STATE OF ALASKA

Department of Public Safety
Division of Administrative Services

Haines Storage IFQ Number: 26AWT0815A Amendment #2

April 2nd, 2026

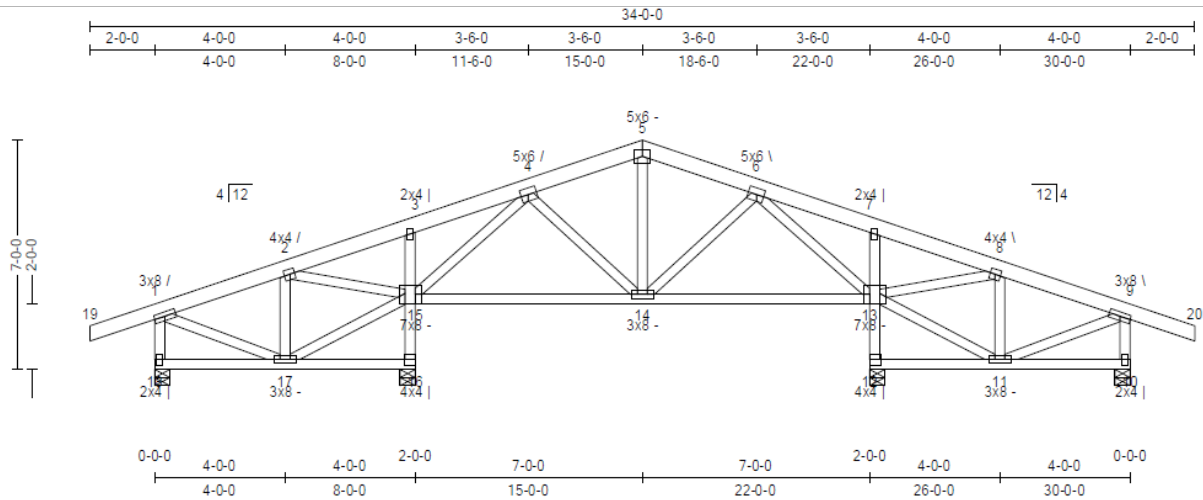
Can you please provide a rough idea and/or address of the location this will be placed?

Located on DOT property on the corner of Union and Allen Street at the far back of the lot marked out in red box. (See picture below)
